AMBERLEIGH COMMUNITY PARK

**Re: Construction Storm Water Inspection at Amberleigh Community Park  
Franklin County  
Permit Number: 4GC03437 \*AG**

Figure 1

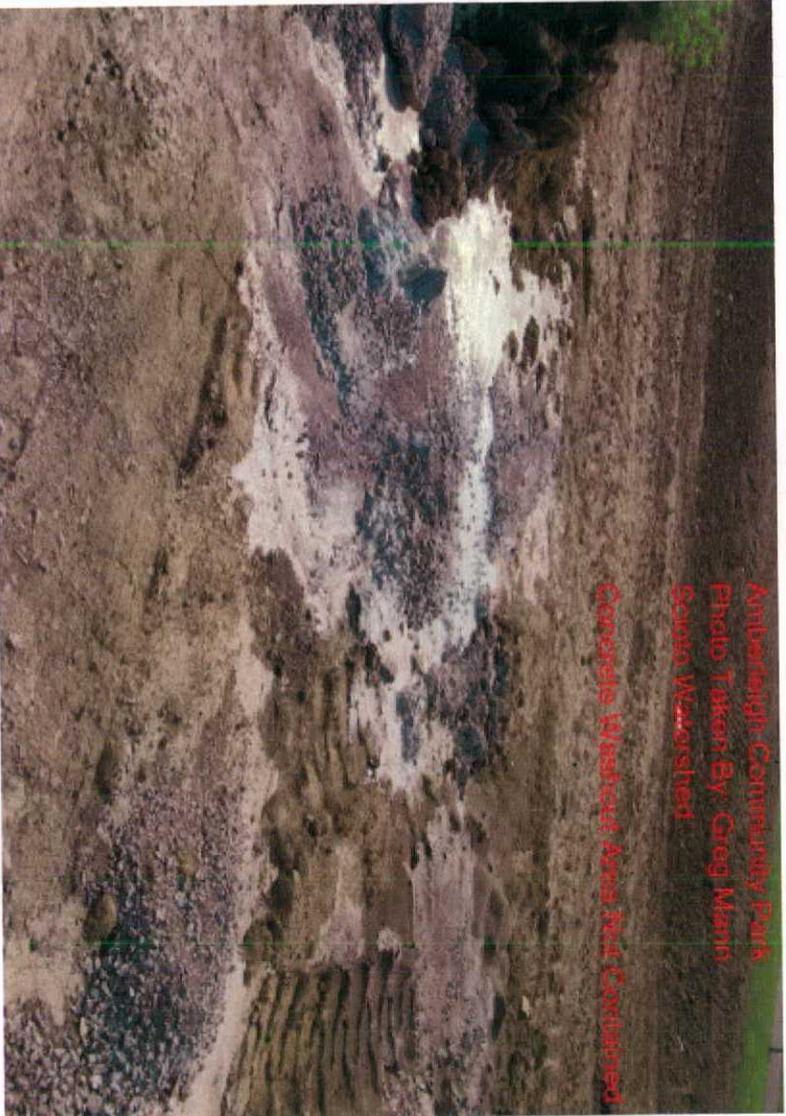
- Our staff noted that perimeter silt fence has failed along the lower (eastern) side of the site. Please perform the necessary maintenance to ensure the silt fences are functioning as intended and offsite sediment transport is minimized (See Figure 1).
- During the inspection our staff noticed improper concrete disposal near the entrance of the site. Please employ corrective measures to implement a proper concrete disposal area (See Figure 2).

Amherstleigh Community Park  
Photo Taken By: Greg Mann  
Santo Watershed  
Failed Perimeter Barrels
